AMENDMENTS TO THE DRAWINGS:

REMARKS

ANNOTATED SHEET

Fig - 1 -

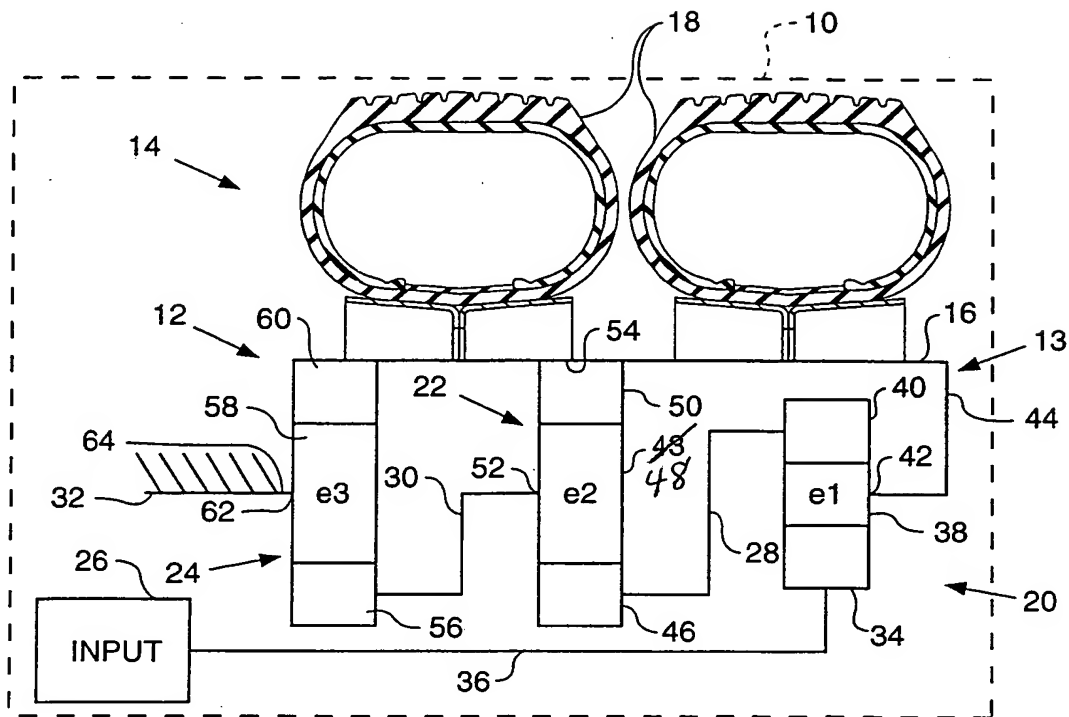
The attached sheet of drawings includes changes to correct a typographical error in Fig. 1. Reference character 43 has been replaced by reference character 48, which is set forth in the specification, e.g., paragraphs 20 and 21.
